Re: City of Palmdale Hybrid Power Plant Project: Docket No. 08-AFC-9

IN THE MATTER OF:) DOCKET NO. 08-AFC-9
)
APPLICATION FOR CERTIFICATION,) REQUEST TO SET DATE FOR
FOR THE PALMDALE HYBRID POWER) EVIDENTIARY HEARING
PROJECT BY THE CITY OF PALMDALE)
)
_____)

From: Felicia Miller
To: Docket Optical System
Date: 8/16/2010 9:52 AM
Subject: PHPP AQ ERC Issues

Re: June 16, 2010 Letter Regarding Palmdale Hybrid Power Project FDOC (08-AFC-9)

Figure 1. Location of PHPP Proposed Emission Reduction Credits

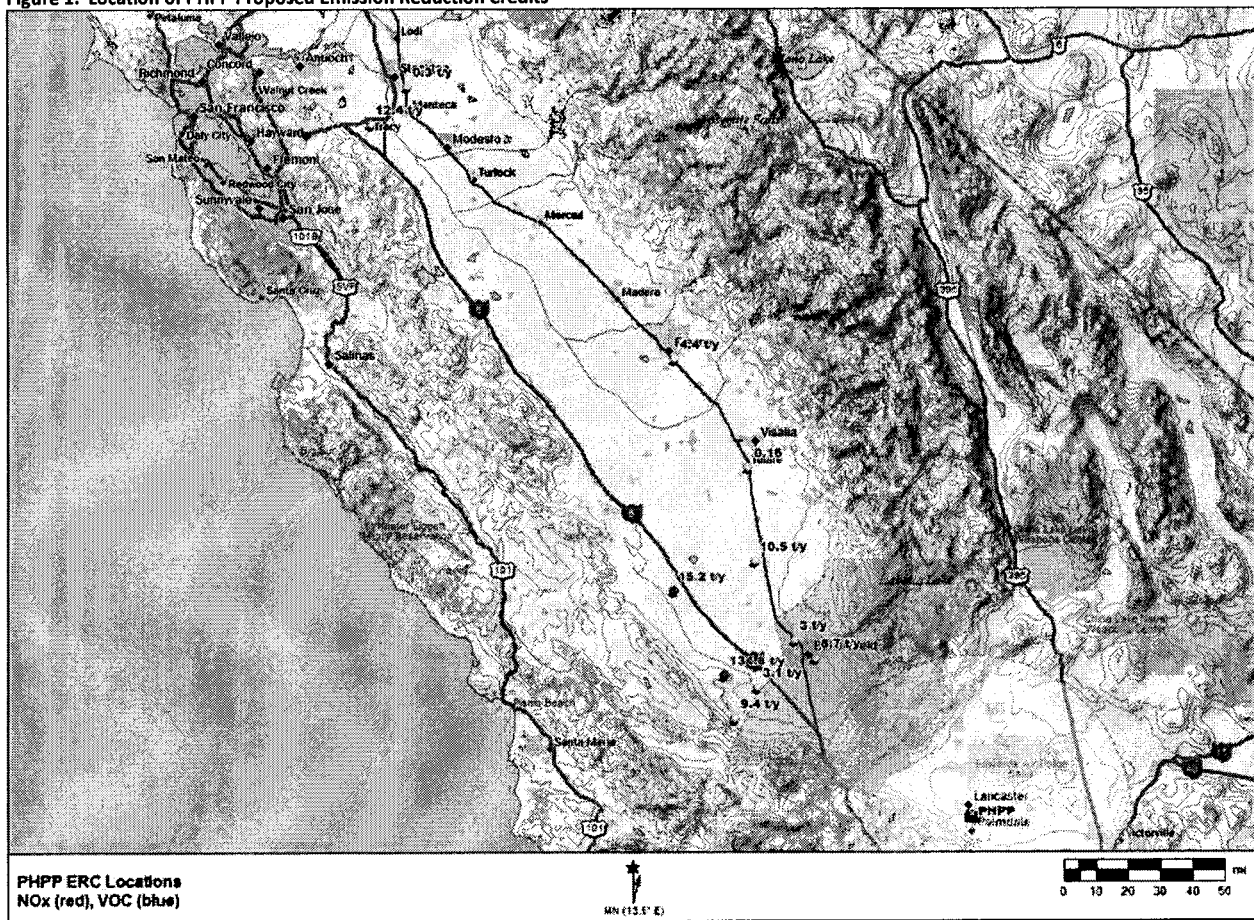
The map below (Figure 1) shows the location of the proposed PHPP ERCs for NOx and VOC. The swap for the ERCs in Stockton and Tracy would involve a trade between Calpine and a currently unknown party to swap for reduction sites in the southern part of the basin. The fact that all of the ERCs are from Calpine, and that there appears to be a need for Calpine to swap ERCs from Stockton and Tracy, would make one suppose that there is some sort of relationship between the applicant and Calpine. There are plenty of other ERCs out there that would avoid the need for Calpine to swap ERCs, but perhaps dealing with just one party simplifies the process for the City of Palmdale.

The yellow circle on the map represents a 50 mile radius around the PHPP, while the salmon colored area represents a 50 mile wide zone extending from the western boundary of the Mojave Desert Air Basin (MDAB). No ERCs have been identified within a 50 mile radius of the PHPP, while only two ERC sources are within 50 miles of the MDAB. However, the majority of the ERCs are not that much further beyond 50 miles from the MDAB, with the main NOx ERCs from Elk Hills about 89 miles from PHPP and 60 miles from the western MDAB boundary (see Table 1). The proposed ERCs all appear to have been properly banked from actual emission reductions. The ERCs were also discounted at the time they were banked in order to produce a net air quality benefit. The main concern that we have at this time is whether or not some of these ERCs are too far from the PHPP to offset project emissions and result in a net air quality benefit.

Figure 2. California Air Districts

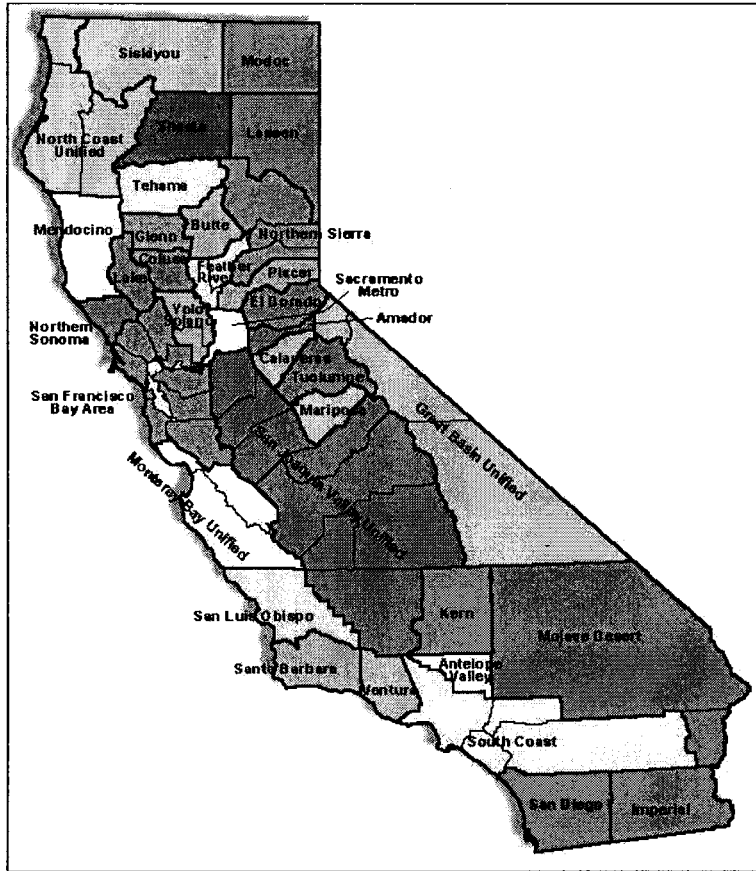
- Should distance ratios be applied to the ERCs from the San Joaquin Valley? Since the AVAQMD is very small (see Figure 2), no distance ratios were included in their rules. If the SJVUAPCD rules are used as guidance, many of the ERCs identified in the San Joaquin Valley would be questionable in terms of offsetting PHPP emissions and demonstrating a net air quality benefit. This is probably a decision best left to the ARB and USEPA prior to project licensing; however, per SJVAPCD Rule 2201 guidance, an offset ratio of 1.5:1 should be used at a minimum give the large distance between the PHPP and proposed ERCs.
